■INTAKE AND EXHAUST SYSTEM

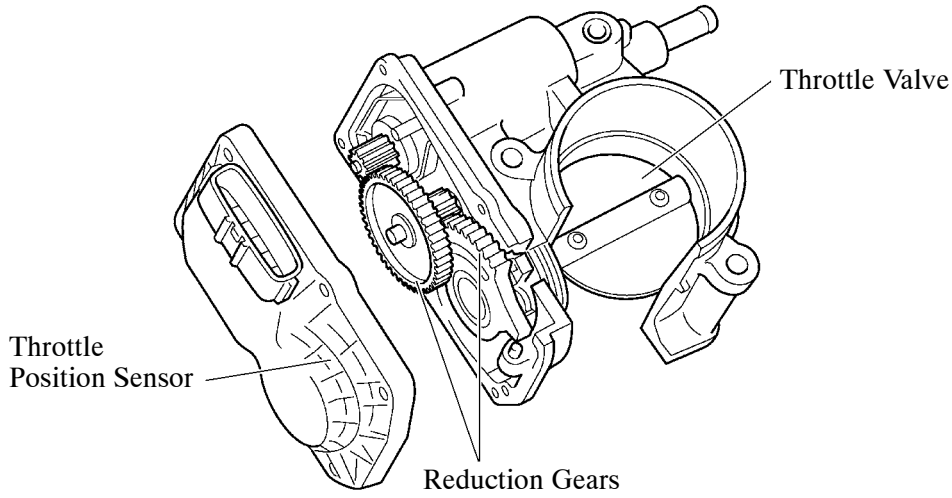
- A newly shaped Air Cleaner Assembly has been adopted.
- A No. 4 Intake Air Resonator (Intake Air Resonator) has been adopted for the No. 2 Air Cleaner Hose.

26T1EG47

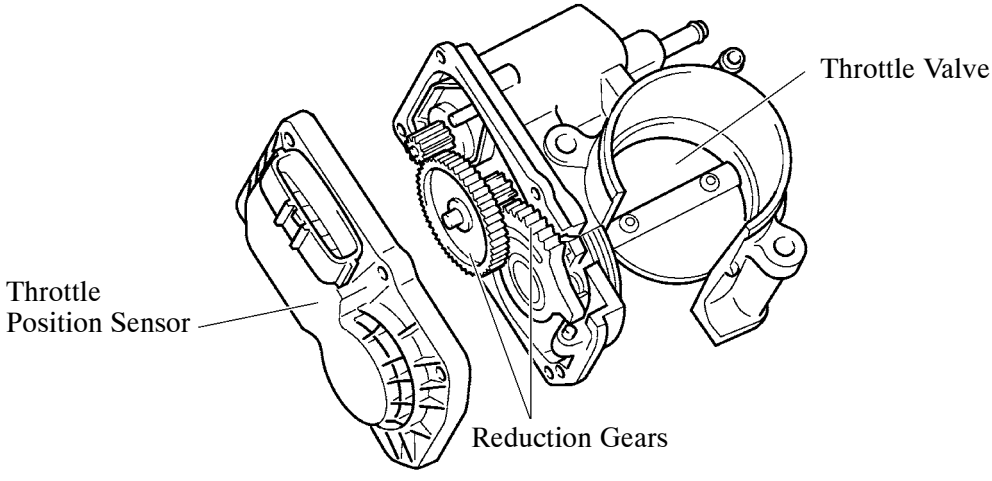
A newly shaped throttle body with motor assembly has been adopted.
